MFN 09-772 Revision 1

Subject: Revised Response to Portion of NRC RAI Letter No. 368 Related to ESBWR Design Certification Application - DCD Tier 2 Section 3.8 - Seismic Category I Structures; RAI Number 3.8-96 S05 Revision 1

RAI Number 3.8-96 S05, Revision 1

Figure 3.8-96(1) Horizontal Forces in Sliding Evaluation (Basemat Plan)

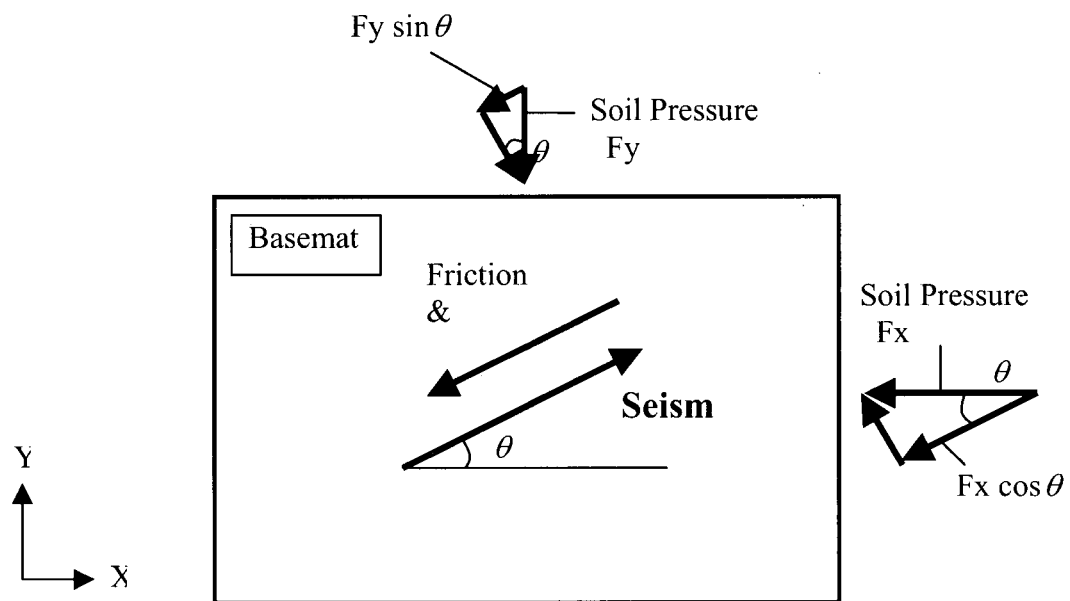
Furthermore, the use of the static frictional resistance at the bottom of the basemat is not consistent with the use of the passive soil resistance at the vertical edge of the basemat. This is because to mobilize the full passive resistance at the vertical edge of the basemat requires some movement of the basemat, in which case, the dynamic sliding friction would be more applicable. Based on the above, GEH is requested to revise their approach to ensure that all of the resisting forces utilized to prevent sliding are developed using a consistent set of assumptions or provide justification for any alternative methods.

Applied horizontal seismic forces and sliding resistances are schematically shown in Figure 3.8-96(1). Among the resistances, the basemat bottom friction and cohesion act in the direction of the resultant seismic force and their magnitudes are the same as those in the 2-dimensional evaluation.

Figure 3.8-96(2) Shear Key Configuration for the RB/FB Structure

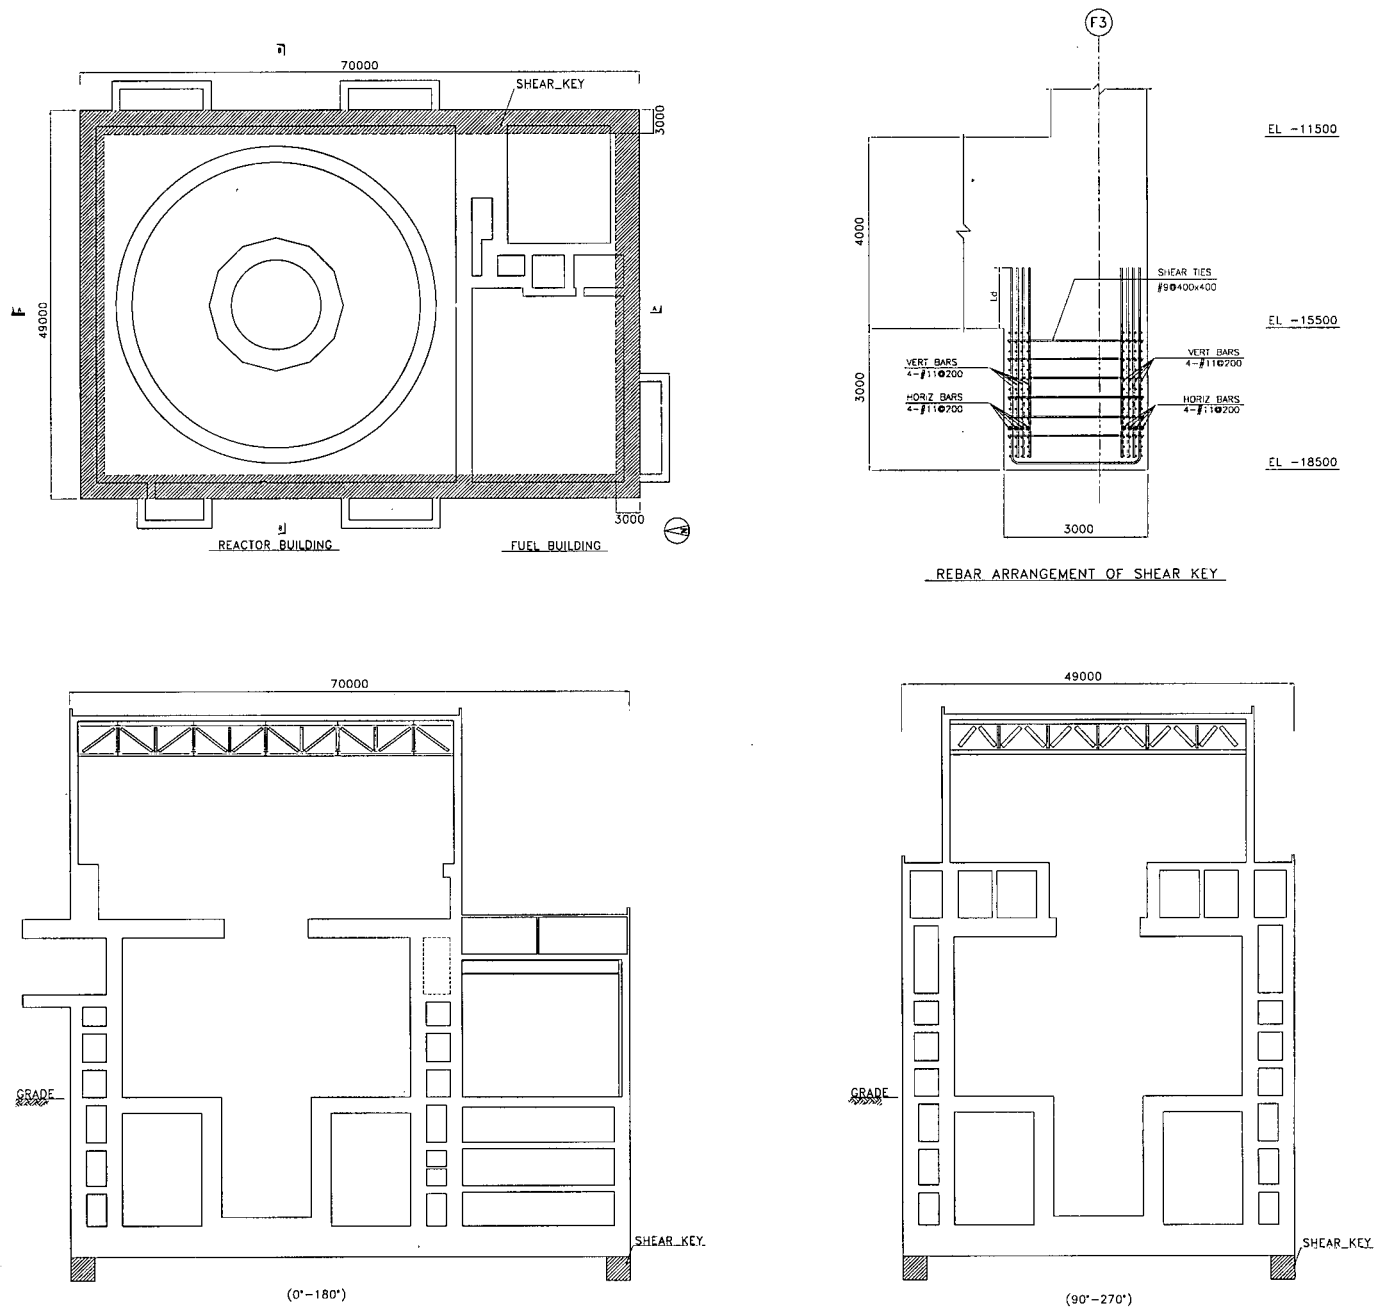
- C) *In Item (9) (pages 22 through 26 of 27), a description of the revised sliding evaluation is presented. This new calculation considers the static coefficient of friction beneath the basemat and on the side walls, passive soil pressures, and at rest soil pressures. As indicated in the prior revision to this RAI, the use of these terms should be based on a consistent set of expected deformations. For example, to develop the full passive pressure capability of the soil implies that sufficient*

The shear key configuration is shown in Figure 3.8-96(2). The reinforcement in the shear key is determined to resist full capacity of the passive pressure less the active pressure.

Figure 3.8-96(4) Coefficient as a Function of Poisson's Ratio

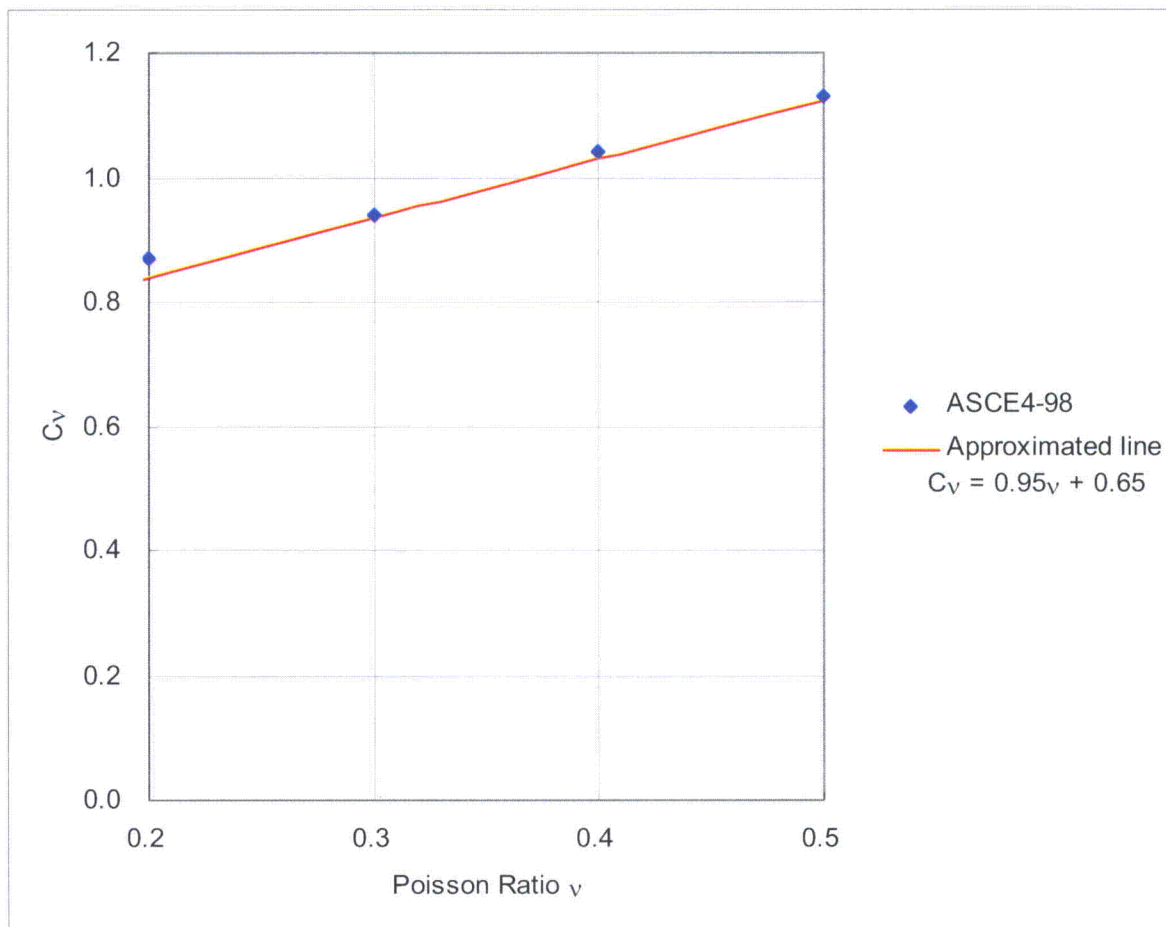
In the same section, GEH also provides the following recommendation: "To ensure the wall design seismic lateral pressures induced from backfill are not exceeded, a COL item will be added in DCD Tier 2 Table 2.0-1 to limit the product of peak ground acceleration (α) of the site-specific Foundation Input Response Spectra (FIRS) in g's, Poisson's ratio (ν) and density (γ) as follows: α ($0.95\nu + 0.65$) γ : 1220 kg/m³ (76 lbf/ft³) maximum." Provide an explanation and the basis for this recommendation.

The seismic lateral pressure limit, $\alpha (0.95v + 0.65) \gamma$, is derived from the resultant force F_r equation in ASCE 4-98, Figure 3.5-2, as follows:

- α : horizontal earthquake acceleration (g)
- γ : soil unit weight
- H : embedment height
- C_v : coefficient as a function of Poisson's ratio, v . A numerical analysis of this equation shows that C_v , the coefficient as a function of Poisson's ratio, can be approximated by a straight line, $0.95v + 0.65$, as shown in Figure 3.8-96(4).

Figure 3.8-96(5) Forces for RB/FB Sliding Evaluation

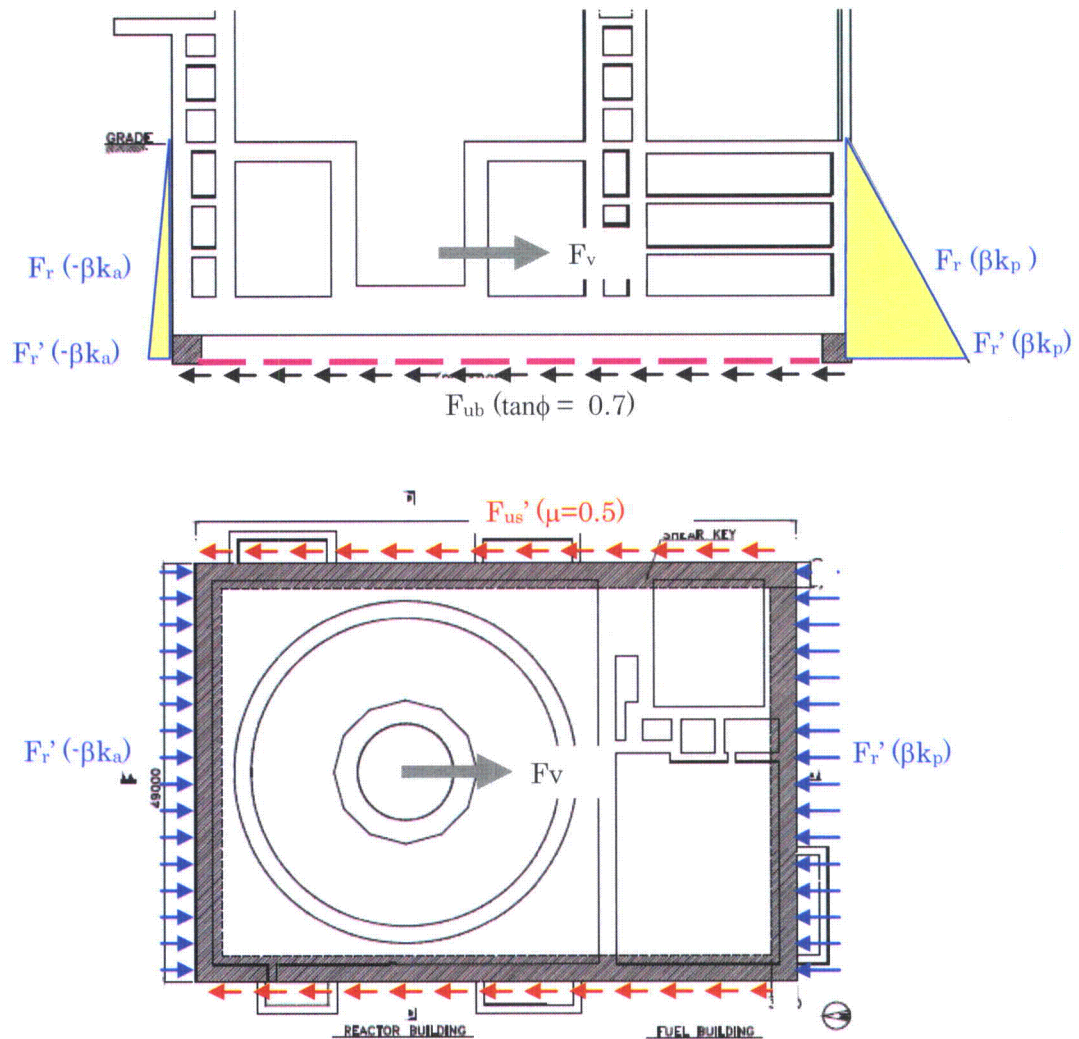
(b) With the troughs added to the bottom of the mud mat and the use of shear keys beneath the basemat, the governing sliding interface may now be a horizontal plane in the soil at the elevation corresponding to the bottom of the shear keys. At this elevation there would no longer be any lateral resistance contribution from the surcharge of the building acting on the shear keys when calculating F_{us}' and F_r' . Explain whether another calculation was performed to determine the sliding factor of safety at the elevation of the bottom of the shear keys and describe the results of that evaluation.

The various driving and resisting forces are illustrated in Figure 3.8-96(5). The revised sliding evaluation is shown at the end of this supplemental response.

The FS is evaluated by taking the minimum values of the $FS(t)$ time history calculated per the following equation. See Figure 3.8-96(5) for each force.

Figure 3.8-96(7) Forces for CB Sliding Evaluation

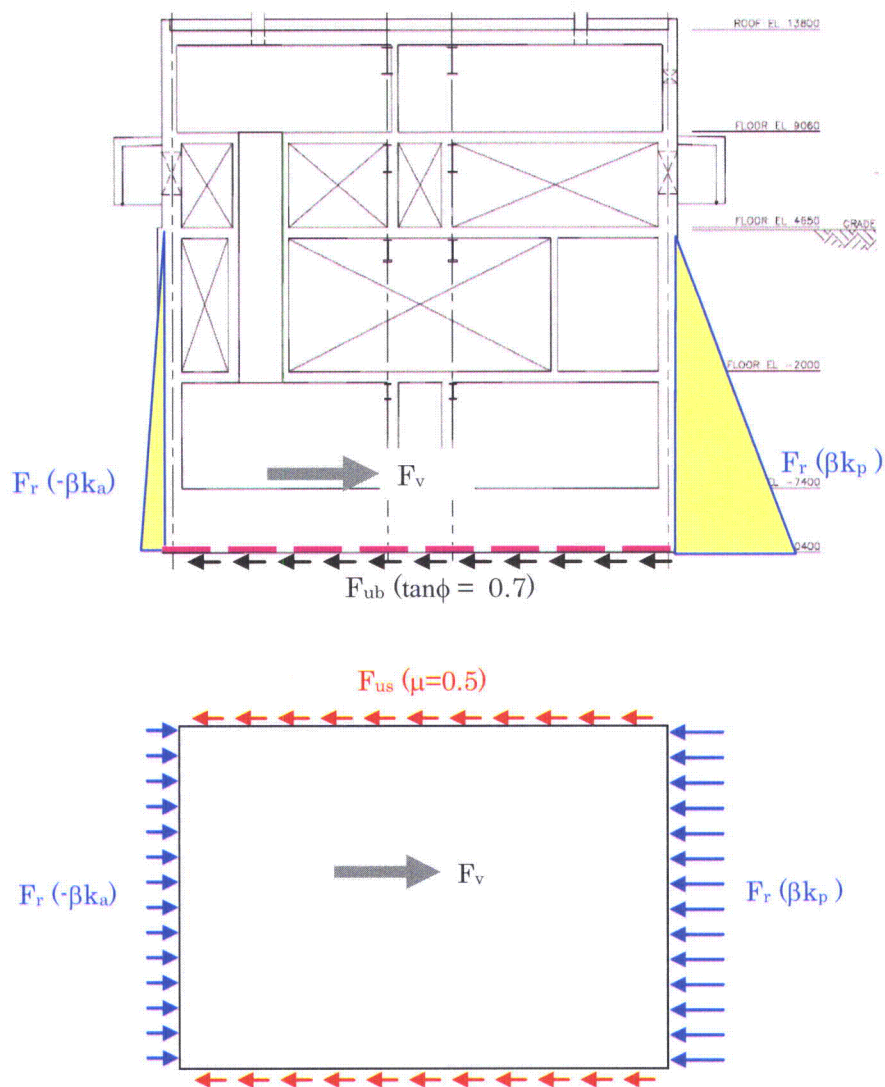
Item D response refers to a sliding evaluation approach presented at the end of the supplemental response. For all three structures (RB/FB, CB, and FWSC), GEH is requested to address the following items for this sliding evaluation:

The FS is evaluated by taking the minimum values of the $FS(t)$ time history calculated per the following equation. See Figure 3.8-96(7) for each force.
